## **FINAL DRAINAGE REPORT**

**MAYBERRY, COLORADO SPRINGS – FILING NO. 4**

**R&R JOB #MC22249  
EPC PROJECT No. SF2317**

**AUGUST 2023**

## Temporary Swale C7 Cross Section - 5 year

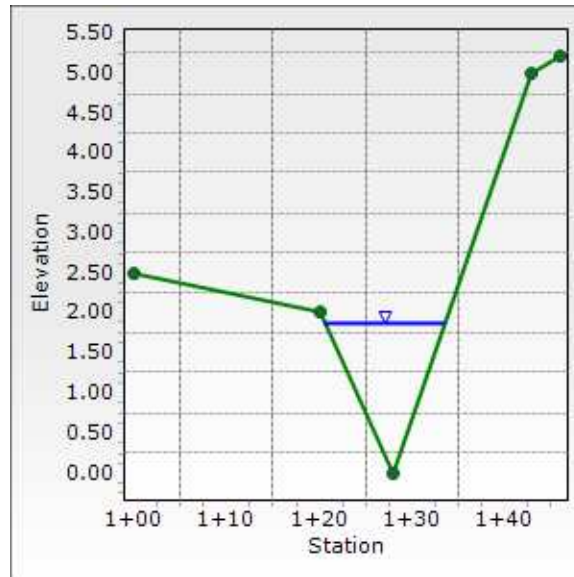
Project Description		
Friction Method	Manning Formula	narrative and drainage plan indicate a 5 year flow of 13.14 cfs. revise accordingly
Solve For	Normal Depth	
Input Data		
Channel Slope	0.001 ft/ft	
Discharge	9.89 cfs

narrative and drainage plan indicate a 5 year flow of 13.14 cfs. revise accordingly

## Temporary Swale C7 Cross Section - 100 year

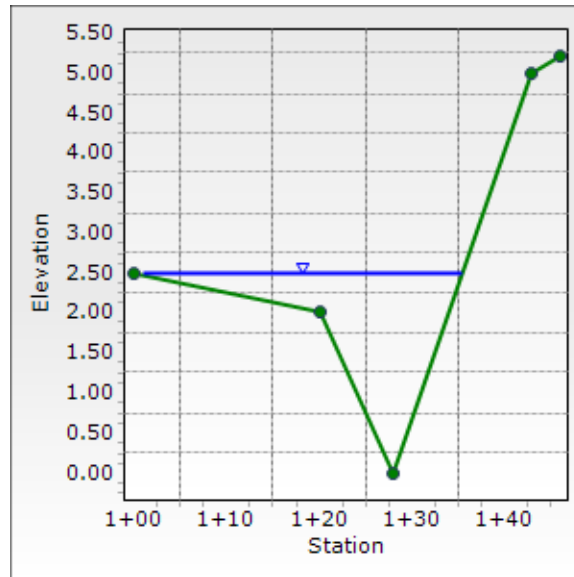
Project Description		narrative and drainage plan indicate a 100yr flow of 23.97 cfs. revise accordingly. Increase the drainage easement as necessary to contain the 100yr flow.
Friction Method	Manning Formula	
Solve For	Normal Depth	
Input Data		
Channel Slope	0.001 ft/ft	
Discharge	18.04 cfs

narrative and drainage plan indicate a 100yr flow of 23.97 cfs. revise accordingly. Increase the drainage easement as necessary to contain the 100yr flow.

**PROPOSED DRAINAGE MAP**

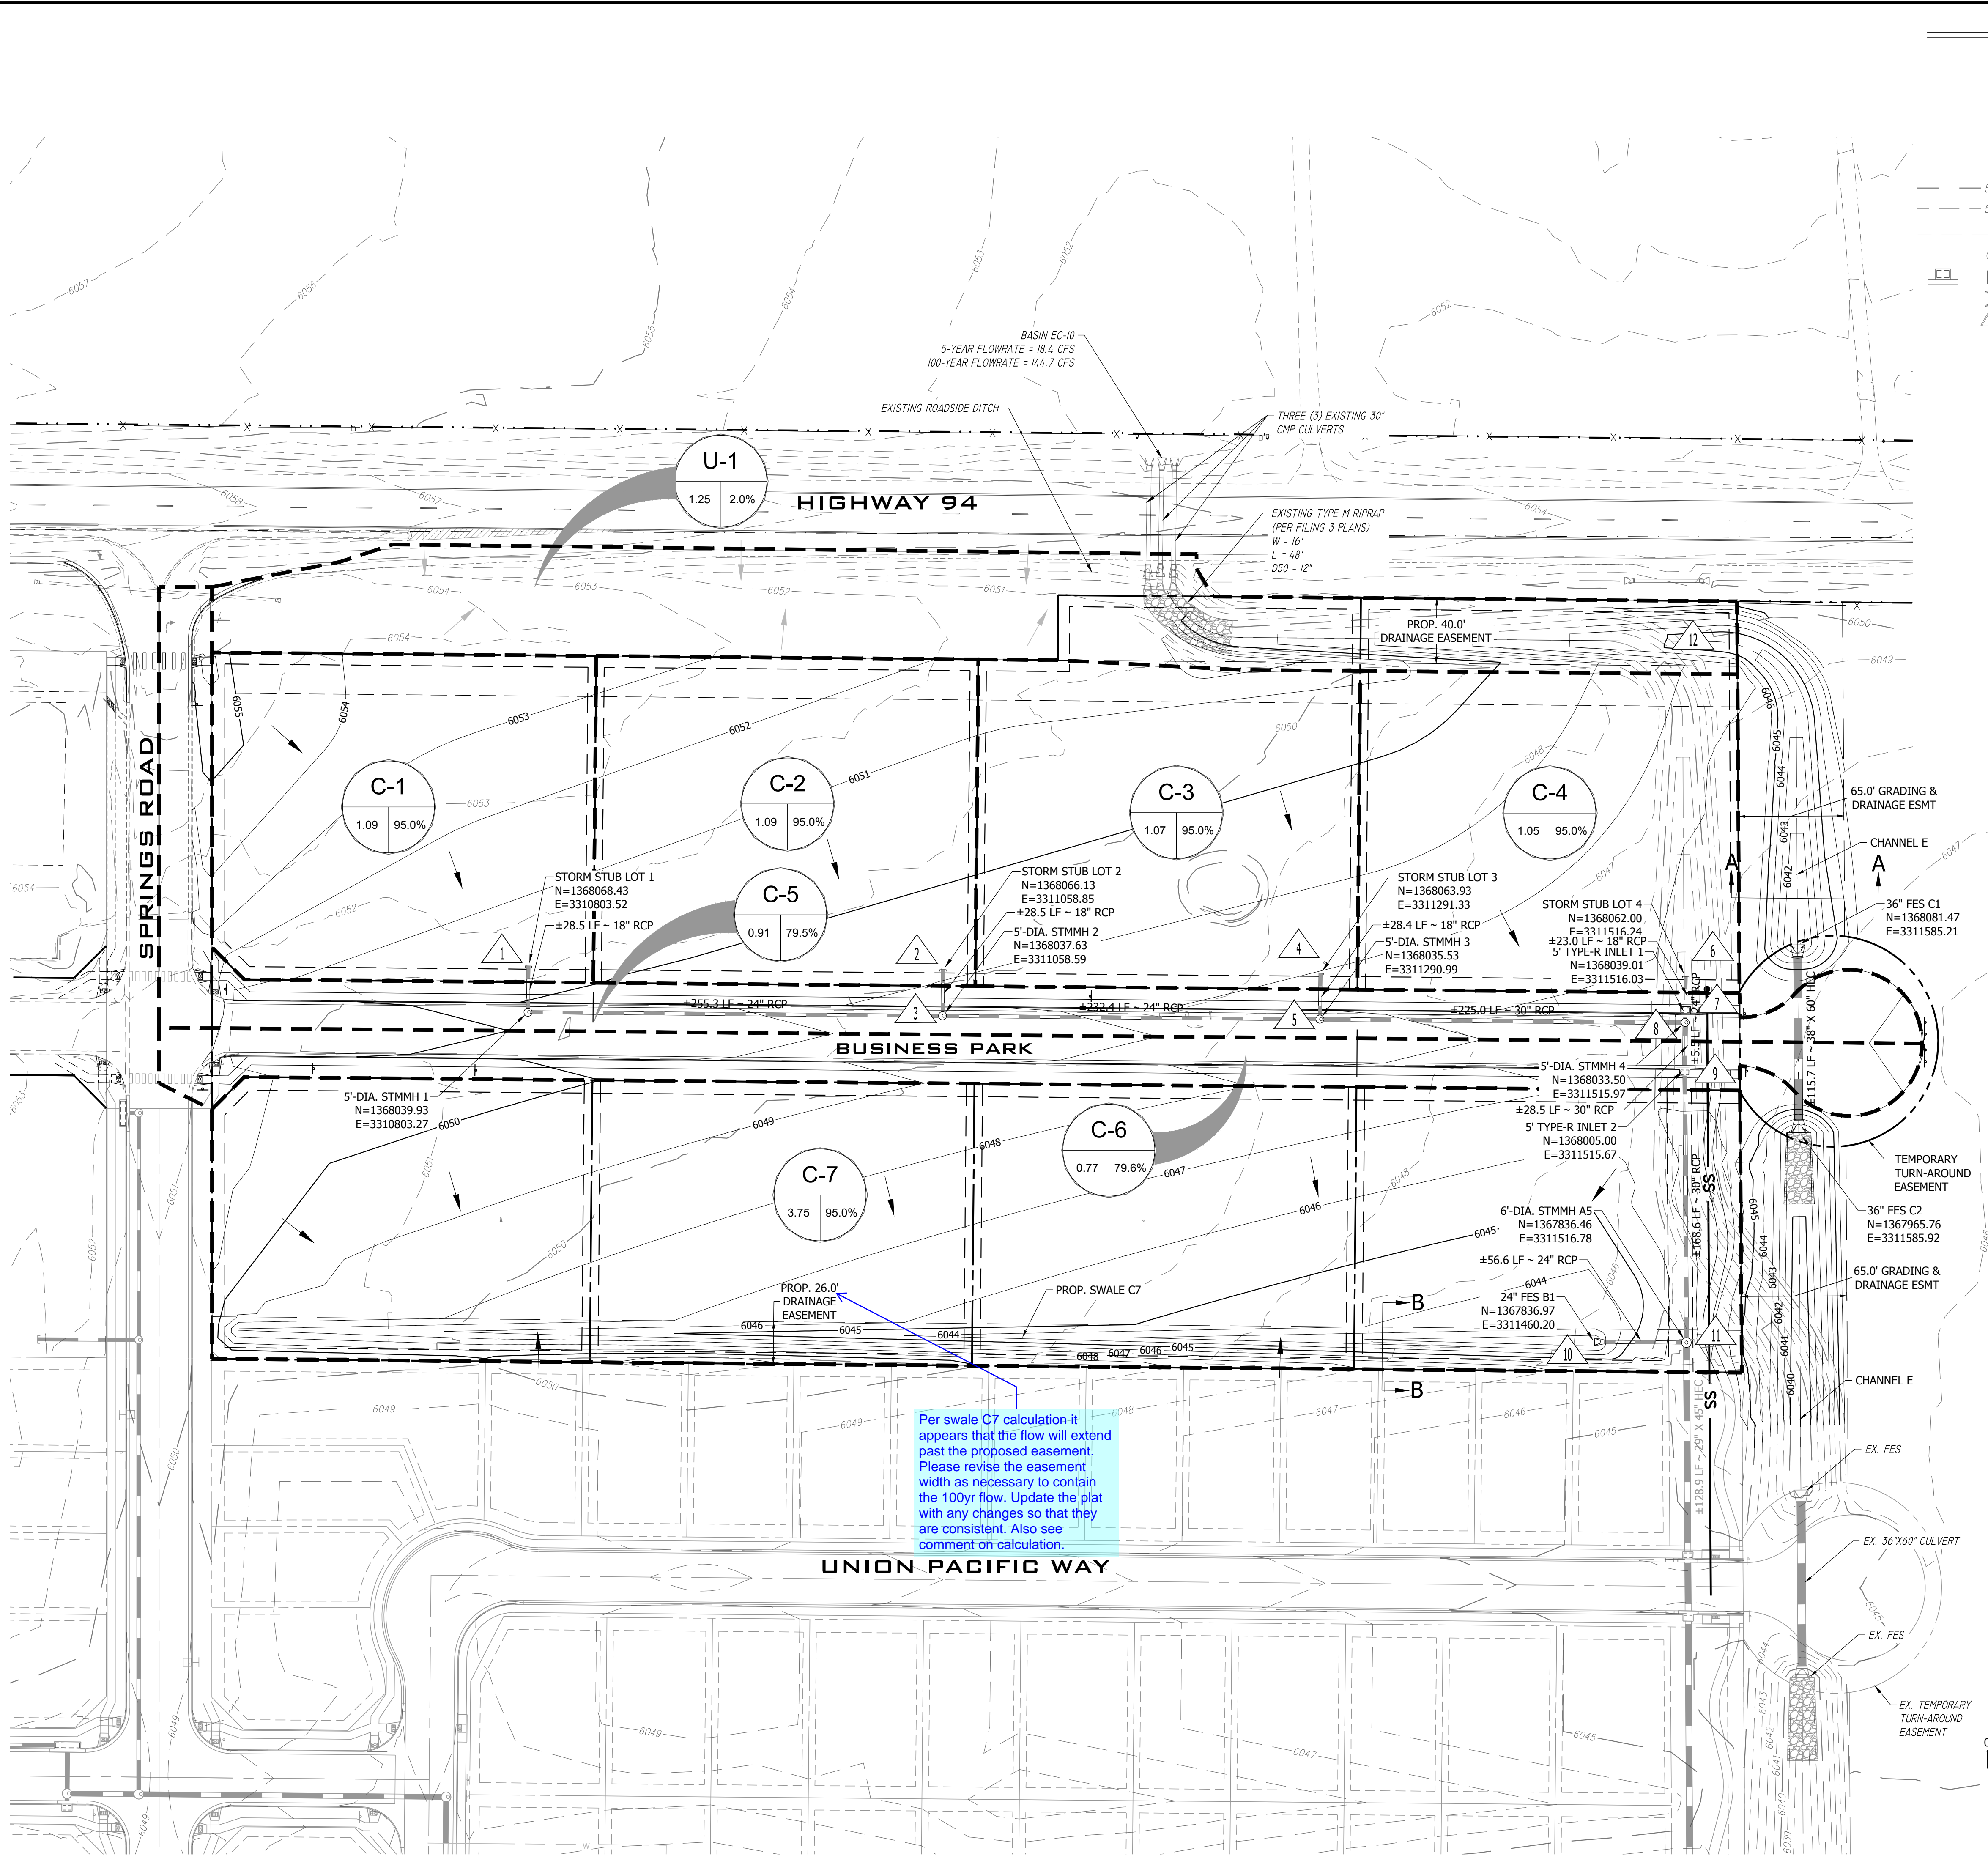
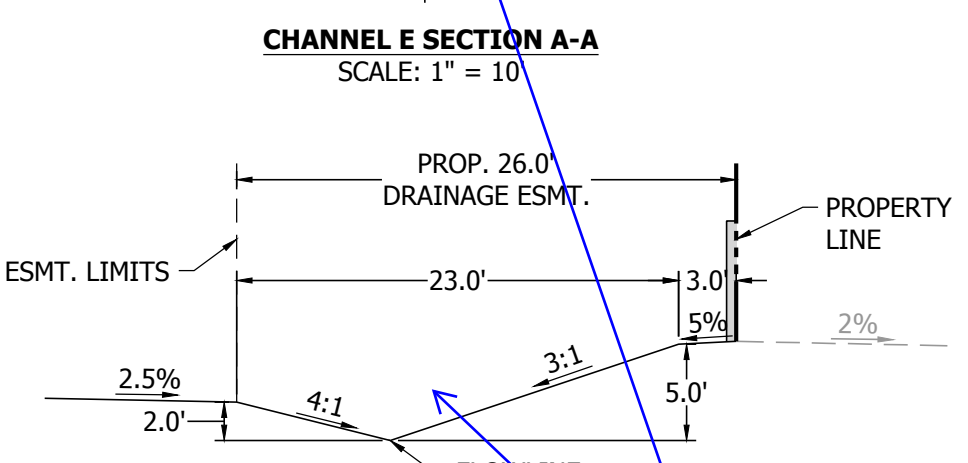
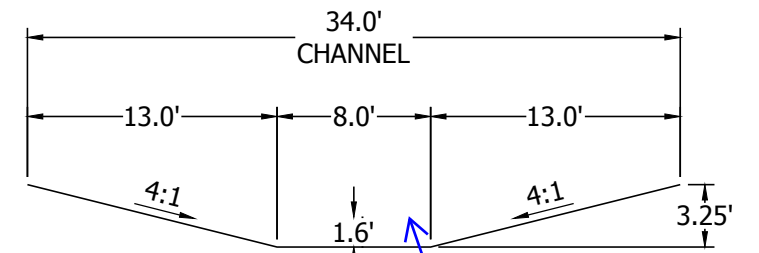
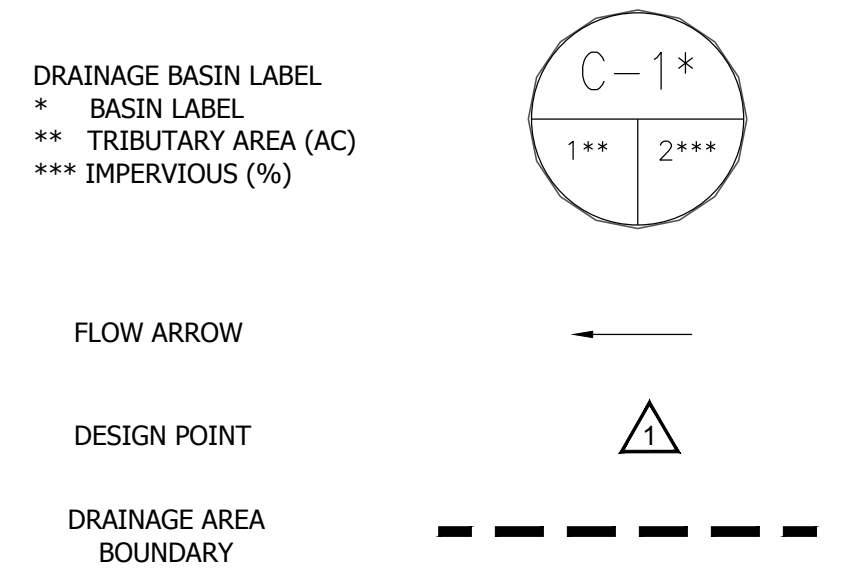
Per swale C7 calculation it appears that the flow will extend past the proposed easement. Please revise the easement width as necessary to contain the 100yr flow. Update the plat with any changes so that they are consistent. Also see comment on calculation.
